Construction Change Order

Project: City of Laredo - Eastern Chacon Creek Interceptor & Drainage Improvements

C. O. No.: 4

Date: February 8, 2024

Sanitary Sewer Manhole Proposed
Rip Rap To Address August 2022
Rain Event

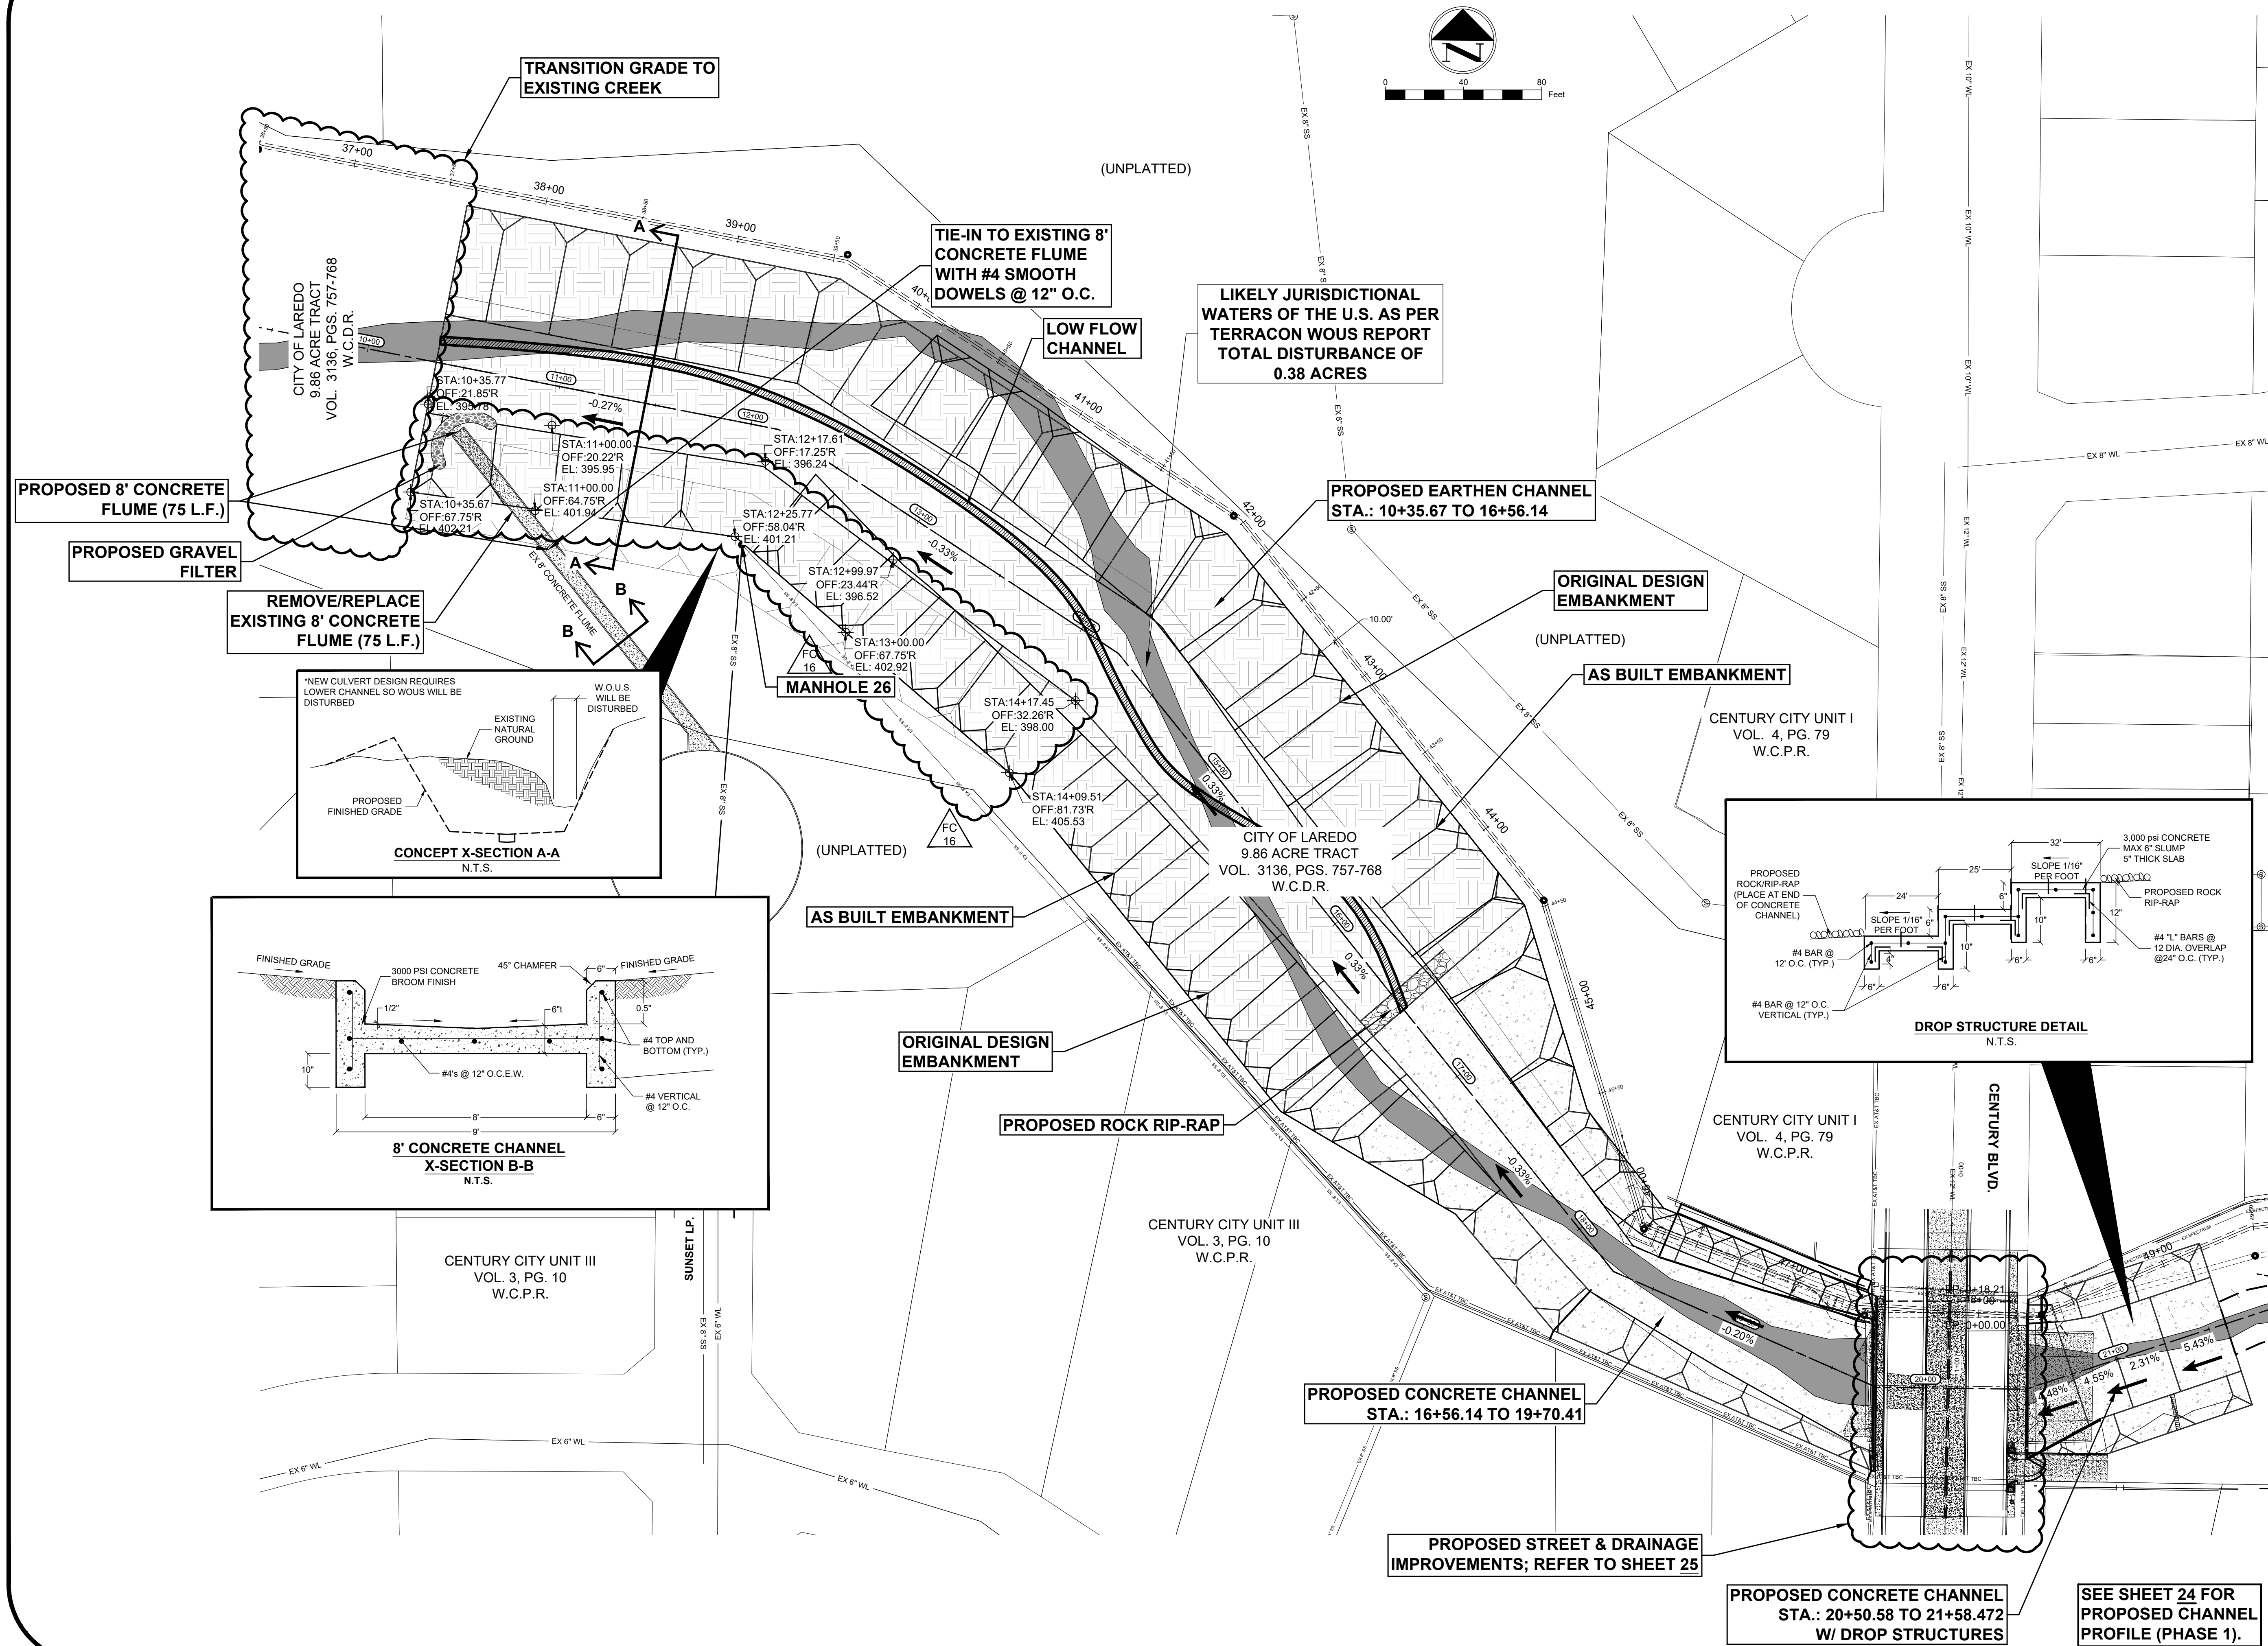
NOTE:
THIS PLAN IS ONLY UPDATING THE SOUTHERN EMBANKMENT OF THE EARTHEN CHANNEL FROM STATION 10+35.67 TO 14+09.51 AND PROVIDING MORE DETAILED INFORMATION ON THE 8' CONCRETE FLUME TO BE REMOVED AND REPLACED.

FIELD CHANGE #16
Sheet Title
PHASE 1-CHANNEL SITE IMPROVEMENTS PLAN

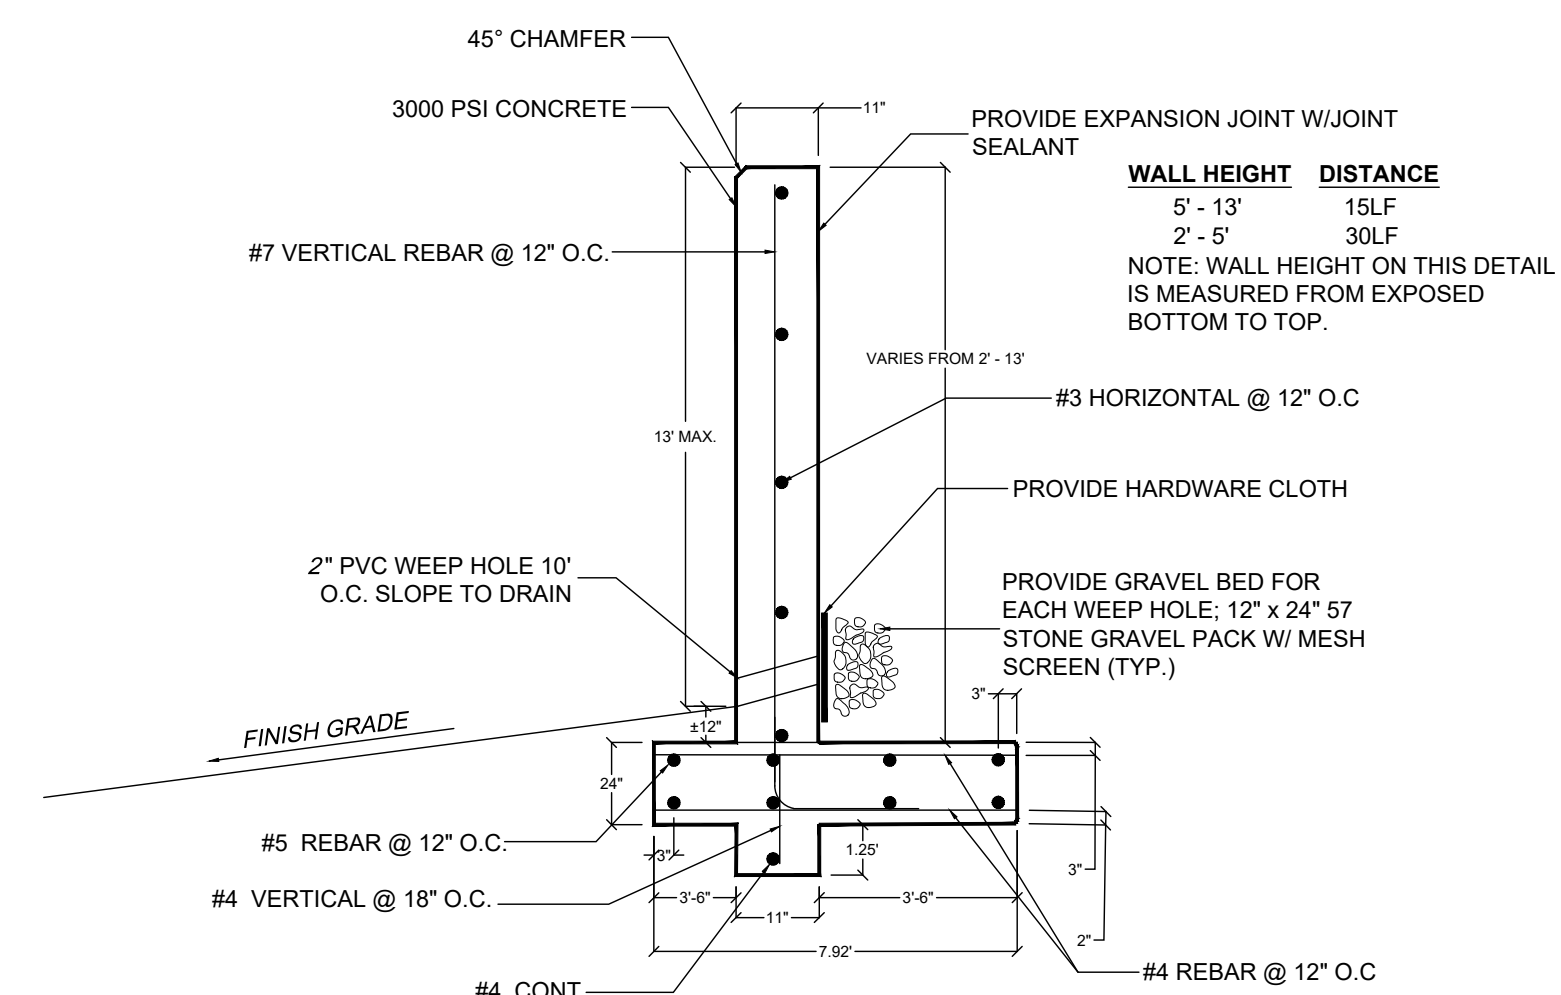
1. Additional 57 stone necessary below concrete lined channel to address groundwater surcharge from continuous rain events;
2. Additional conduit to prepare for future hike/ bike trail crossing at Century City bridge;
3. Retaining walls necessary to address current site conditions, maintain hydraulics, and protect as-built wastewater line (200 SF deduct of Concrete Rip-Rap);
4. Concrete rip rap (902 SF) at SS MH's #1.1 & 1.2 necessary to address erosion caused by 100 yr storm (8/22) and protect integrity of manholes;
